PR/0181/23

Record of Executive Business and Chief Executive's Order

Reg. Reference: SDZ22A/0018 **Application Date:** 15-Dec-2022
Submission Type: New Application **Registration Date:** 15-Dec-2022

Proposed Development: Construction of a mixed-use development comprising 594 apartments, office floorspace, 4 retail units, a creche and urban square in the Clonburris Development Areas CUCS3 & CSWS3 of the Clonburris SDZ Planning Scheme 2019 as follows, 594 apartments (255 one bedroom apartments, 307 two bedroom apartments and 32 three bedroom apartments (all apartments to have terrace or balcony; ancillary communal amenity spaces for residents) as follows; Block A (4 and 6 storeys with undercroft) comprises 96 apartments consisting of 36 one bedroom apartments, 48 two bedroom apartments and 12 three bedroom apartments (with creche c. 609sq. m at ground and first floor as well as play area; Block B (6 storeys with undercroft) comprises 77 apartments consisting of 44 one bedroom apartments, 28 two room apartments and 5 three bedroom apartments; Block D (5 and 7 storeys with undercroft) comprises 71 apartments consisting of 39 one bedroom apartments and 32 two bedroom apartments; Block

Figure 1- Overall Street layout proposed

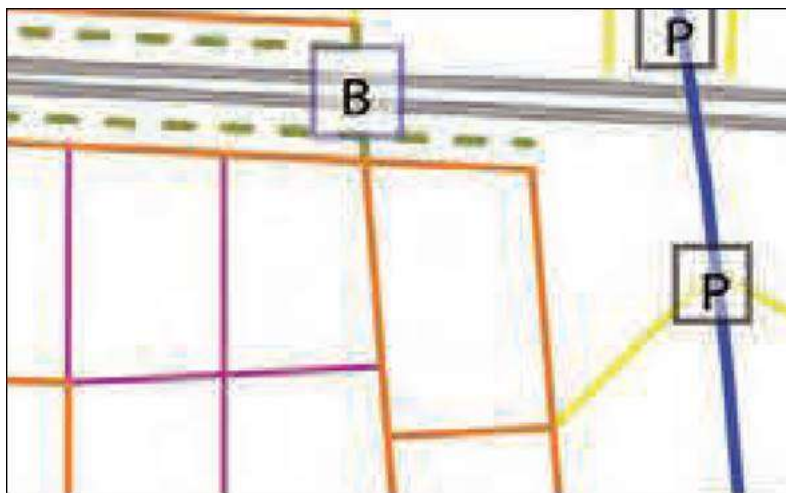
1. *“Homezones South and West of Block G:
This section of homezone should continue to the South Western corner of Block G before continuing along the West of Block G. The SDZ designates this street as a Homezone but the proposal is to make this a Local Street (Fig. 3). No justification has been given for this deviation.*
2. *North/South Pedestrian/Cyclist Route:
This pedestrian/cyclist route is not included in the SDZ plan. It is however a welcome addition which provides a pedestrian/cyclist connection onto the Southern Link Street via a filter junction. The SDZ designates a Local Street to the West of the Public Square. This has been replaced in the application by a pedestrian/cyclist route. This is considered a necessary deviation as it is required to match the junction locations the Southern Link Street (SDZ20A/0021)”.*

Section 2.2.4 of the Scheme outlines that the centre line and alignment of the Local Streets and Homezones are flexible with the exception of streets with frontages prescribed under Section 3 (Development Areas). In this instance, the application site contains prescribed frontages in the form of Avenue Frontage and Railway Frontage and Park Frontage (Figure 3.1) as per image below.

Figure 2.2.6 Example Local Streets including Homezones (Intimate Scale)

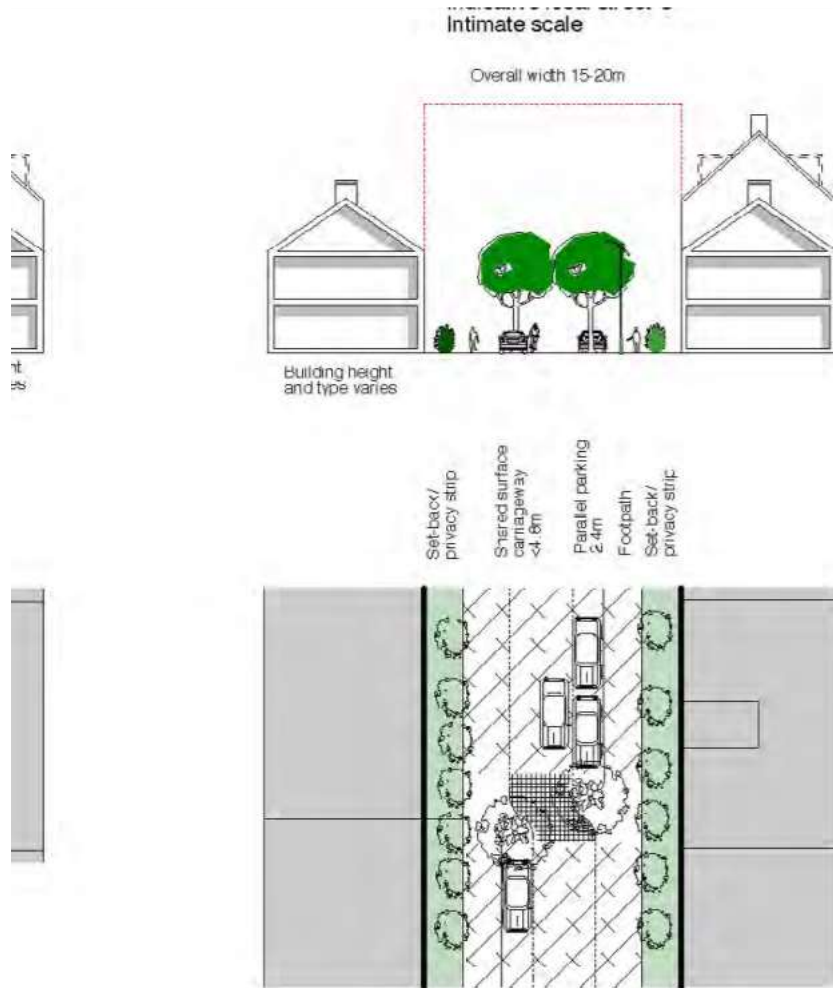
The applicant is requested to provide a clear layout plan indicating:

- The road typology
- Width between building frontages (including areas with planning permission or under consideration applications)
- Carriageway width
- Footpath width
- Privacy strip width (if present)
- Location of street trees.

Additional information is requested.

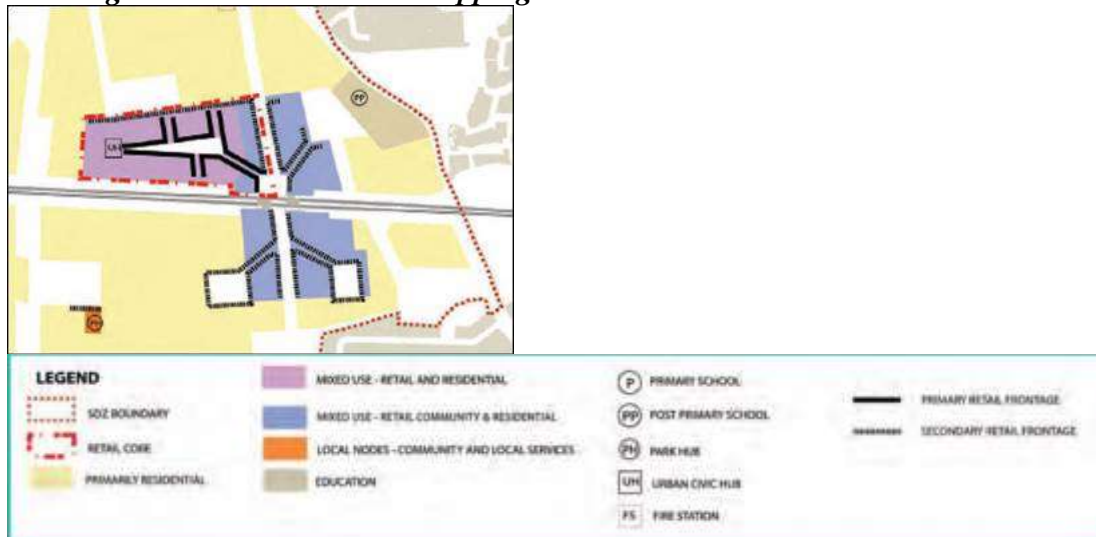
*It is noted that, whilst some retail is provided at ground floor, a significant portion of the shopping streets (secondary retail frontage in this instance) are not retail use. Whilst the provision of other uses, such as the creche is welcomed, it is apparent that a significant portion of shopping frontage is dedicated to residential amenities and areas for plant or cycle storage. The applicant is requested to provide more active / flexible space along the secondary frontages. **Additional information** is requested.*
